## **HIGHWAY 90-INTERSTATE 10 BUSINESS PARK SUBDIVISION, RESUBDIVISION OF LOTS 1 AND 2**

Engineering Comments: FINAL PLAT COMMENTS (should be addressed prior to submitting the FINAL PLAT for review and/or signature by the City Engineer):

APPLICATION NUMBER 7 DATE September 16, 2021

# DETAIL SITE PLAN

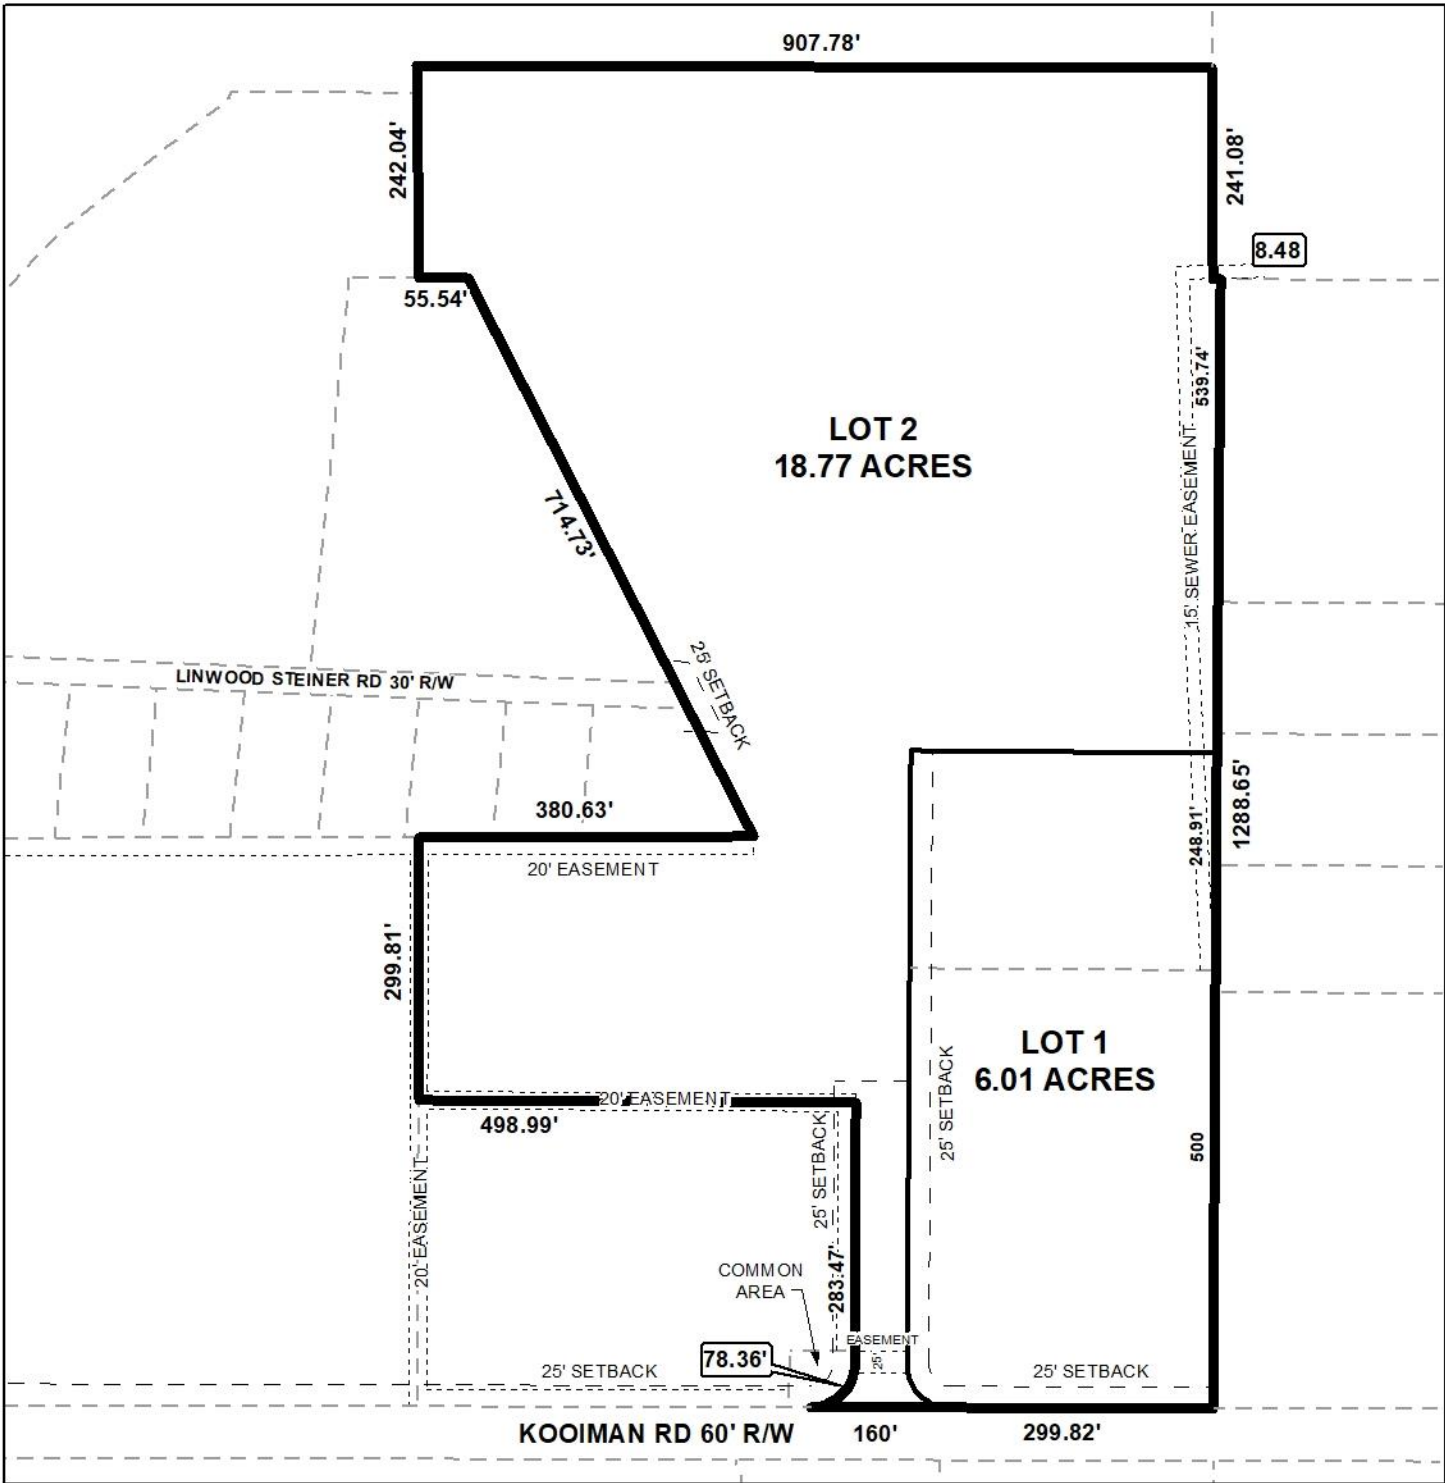
The proposed lots exceed the 7,200 square foot minimum lot size requirement for a lot served by public water and sanitary sewer systems. The preliminary plat provides the lot sizes in acres only; if approved, the lot size information should be provided in square feet and acres on the Final Plat.

The site has frontage on Kooiman Road and Linwood Steiner Road, both minor streets without curb and gutter, which should have rights-of-way of 60-feet. Kooiman Road has a compliant right-of-way; however, Linwood Steiner Road is shown as having a 30-foot right-of-way. As Linwood Steiner Road stubs into the site, and no access is proposed (per a note on the plat), no dedication should be required. A note containing Traffic Engineering comments should be placed on the Final Plat, if approved.

The preliminary plat illustrates a 25’ minimum building setback line along Kooiman Road and Linwood Steiner Road. The setback is also illustrated along a portion of the interior lot line for the proposed Lot 1. If approved, the 25’ setback should be illustrated only along public street frontages on the Final Plat.

Proposed Lot 2 contains a sewer easement. If approved, the Final Plat should contain a note stating that no structures are allowed in an easement without the approval of the easement holder.

It should be noted that as depicted, the proposed Lot 1 will be split zoned B-5 and I-1, as the boundary between those zoning districts lines up with the existing property boundary. Therefore, if the Subdivision is approved, the property will need to be successfully rezoned prior to the signing of the Final Plat.

- 1) provision of the lot sizes in square feet and acres;
- 2) retention of the 25' minimum building setback line along public rights-of-way only;
- 3) successful rezoning of Lot 1 prior to the signing of the Final Plat;

- 4) retention of the note on the Final Plat stating that no further subdivision of Lot 2 shall be allowed until additional frontage on a public street is provided via the construction of a road;

- 5) placement of a note on the Final Plat stating that no structures are allowed in an easement without the approval of the easement holder;
- 6) full compliance with Engineering comments: (FINAL PLAT COMMENTS *(should be addressed prior to submitting the FINAL PLAT for review and/or signature by the City Engineer):* A. Remove the County Engineer's signature block from the plat. As of 3-16-2014 The County Engineer no longer signs plats within the municipal limits of the City of Mobile. B. Provide all of the required information on the SUBDIVISION PLAT (i.e. signature blocks, signatures, certification statements, written legal description, required notes, legend, scale, bearings and distances) that is required by the current Alabama State Board of Licensure for Professional Engineers and Land Surveyors. C. Provide the recording information for the legal description. D. Provide and label the monument set or found at each subdivision corner. E. Add legible street names to the vicinity map. F. Add a signature block for the Owner of the existing LOT 1 (Gulf Equipment Corporation). All property owners are required to sign the Plat. G. Add a signature block for the City Engineer. H. Provide the Surveyor's and Owner's (notarized) signatures. I. Revise NOTES #3 to read City of Mobile instead of Mobile County. This property is located within the City limits of Mobile. J. Revise NOTES #13 – delete the last sentence. A stormwater detention/WQ maintenance plan/agreement will be required to be submitted with the Land Disturbance Permit. K. Label the drainage and utility easements as PRIVATE (not maintained by the City of Mobile). L. Add a note to the SUBDIVISION PLAT stating that as shown on the 1984 aerial photo (FLIGHT 21 - #92) LOTS 1 and 2 will receive historical credit of existing (1984) impervious area towards stormwater detention requirement per Mobile City Code, Chapter 17, Storm Water Management and Flood Control) as follows: LOT 1 – NONE and LOT 2 - NONE. M. Add a note that a Land Disturbance permit will be required for any land disturbing activity in accordance with Mobile City Code, Chapter 17, Storm Water Management and Flood Control); the City of Mobile, Alabama Flood Plain Management Plan (1984); and the Rules For Erosion and Sedimentation Control and Storm Water Runoff Control. N. Add a note that the approval of all applicable federal, state, and local agencies (including all storm water runoff, wetland and floodplain requirements) will be required prior to the issuance of a Land Disturbance permit. O. Add a note that sidewalk is required to be constructed, and/or repaired, along the frontage of each lot, or parcel, at time of new development or construction, unless a sidewalk waiver is approved. P. Add a note that all existing and proposed detention facilities, common areas, and wetlands shall be the responsibility of the Property Owner(s), and not the responsibility of the City of Mobile. Q. Add a note that all easements shall remain in effect until vacated through the proper Vacation process. R. Email a pdf copy of the FINAL SUBDIVISION PLAT and LETTER OF DECISION to the Permitting Engineering Dept. for review at [land.disturbance@cityofmobile.org](mailto:land.disturbance@cityofmobile.org) prior to obtaining any signatures. No signatures are required on the drawing. S. After addressing all of the FINAL
